MULTIPLE ELECTRICAL MALFUNCTIONS AFTER BODY REPAIR

TECHNICAL SERVICE BULLETIN

Reference Number(s): 09-010/19, Date of Issue: August 07, 2019

MAZDA: 2016-2019 CX-3; 2013-2019 CX-5; 2016-2019 Mazda2; 2014-2018 Mazda3; 2014-2019 Mazda6

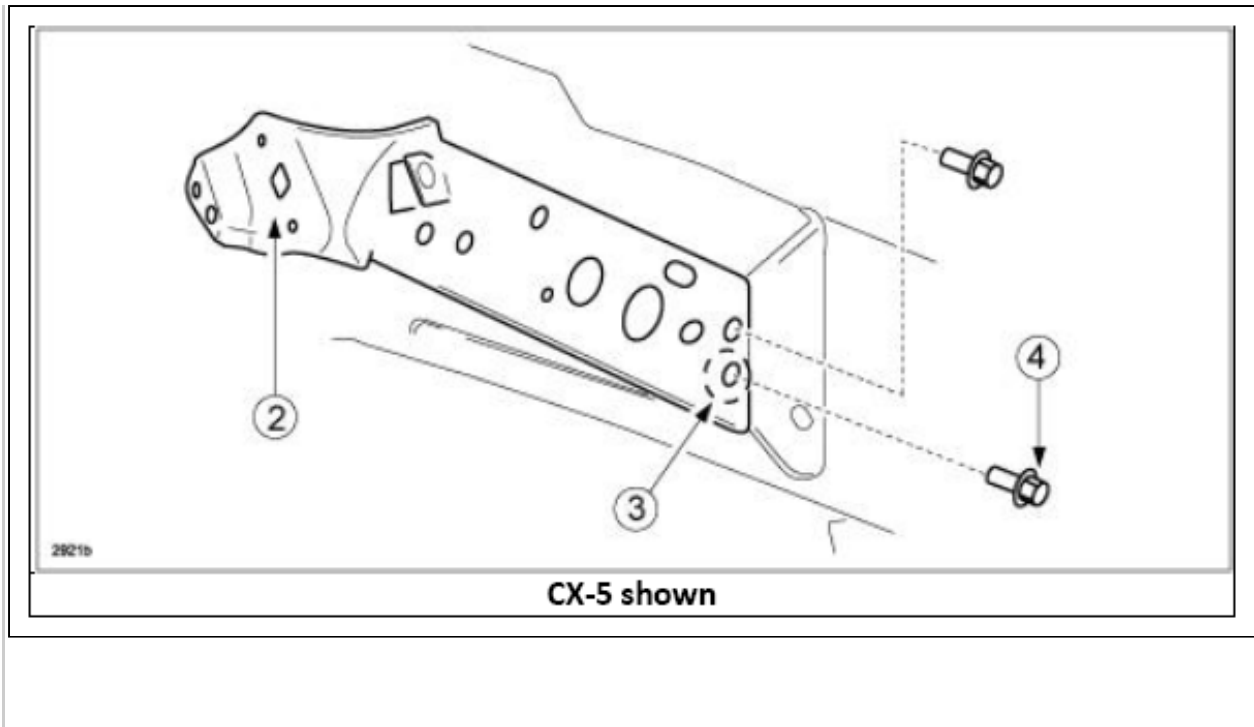
Some customers may experience one or more electrical malfunctions after a vehicle body repair. The newly painted fender stay (2) may be causing a poor front harness (1) ground connection.

The front fender stay (2) newly painted surface at ground point (3), where attachment bolt (4) is seated, may create a poor front harness ground connection.

NOTE: Do not paint ground point (3) where attachment bolt (4) is seated.

Customer concern can be resolved by sanding off paint at ground point (3) where attachment bolt (4) is seated. After installing the bolt (4), apply touch-up paint to the exposed base material area of the front fender stay.

NEWLY INSTALLED FRONT FENDER STAY NOTE

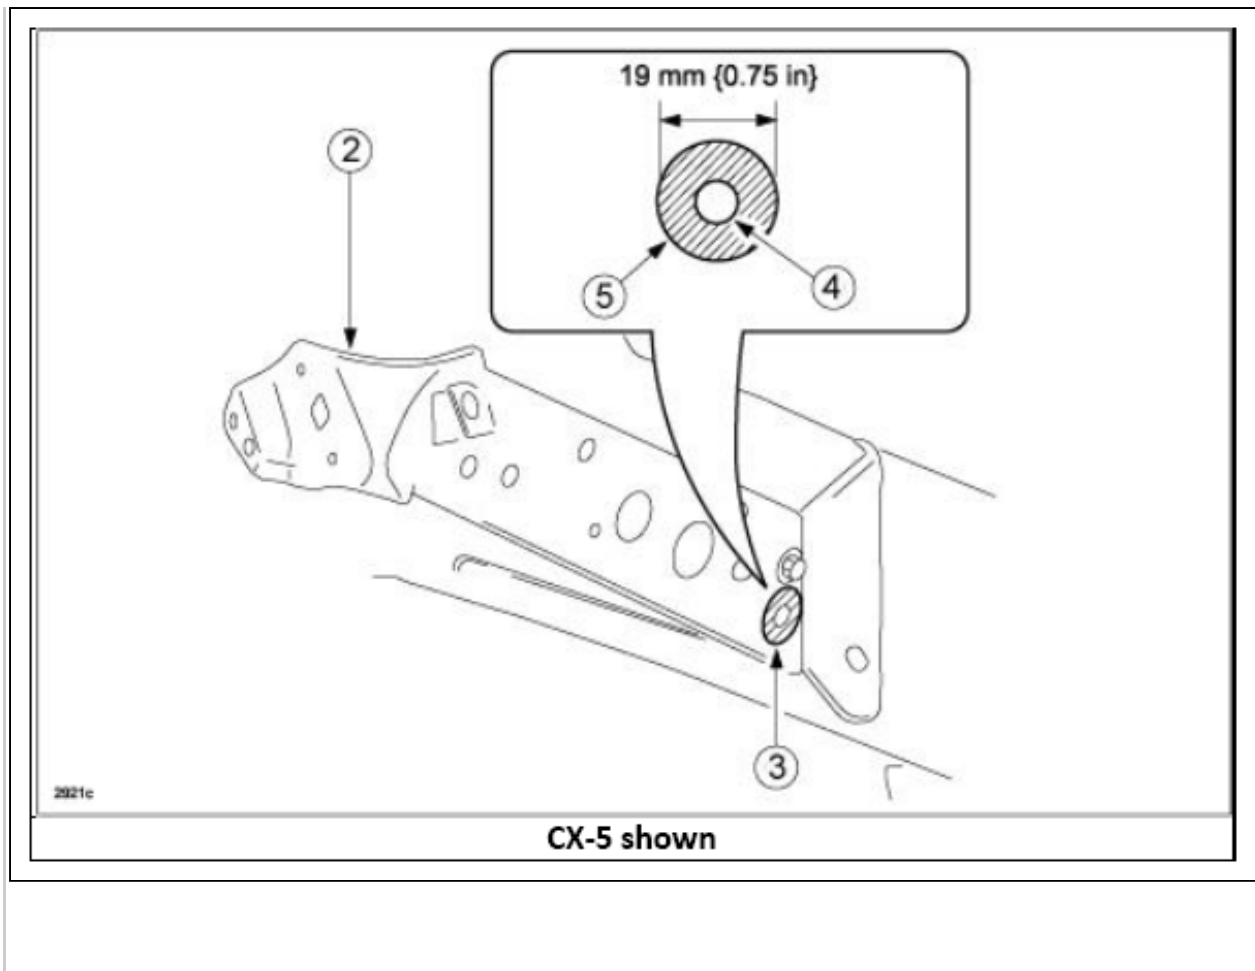
CAUTION: If the bolt (4) contact area (3) is painted when the front fender stay (2) is newly replaced, it could cause a malfunction in the PCM. Before painting a newly replaced part, protect the bolt (4) contact area (3) with masking tape (5) as shown in the figure.

NOTE: After installing the bolt (4), apply touch-up paint to the exposed base material area of the front fender stay.

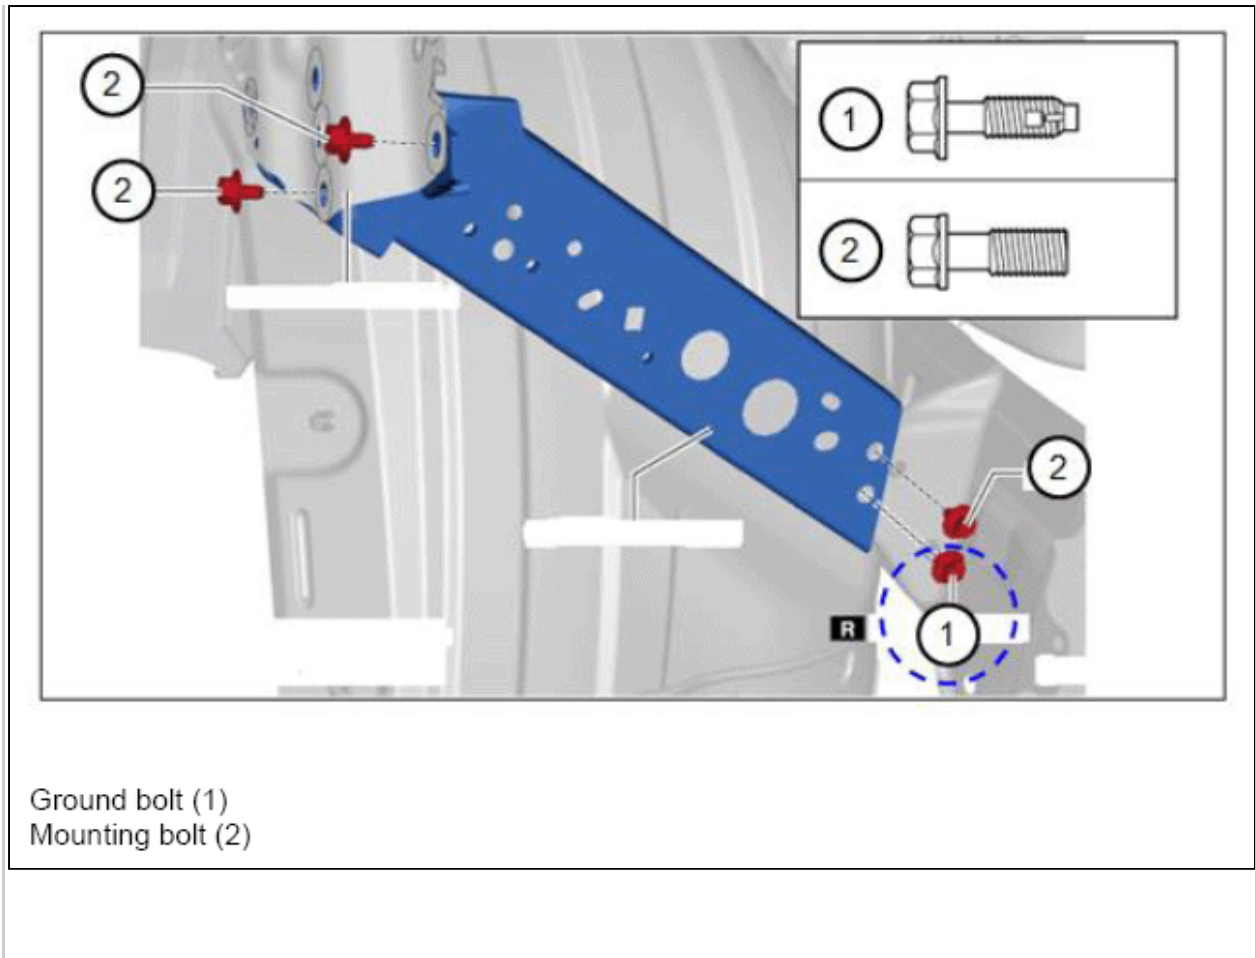
NOTE: Always replace the ground bolt (1) if the Workshop Manual or Bodyshop Manual instructs to use the ground bolt for proper grounding.
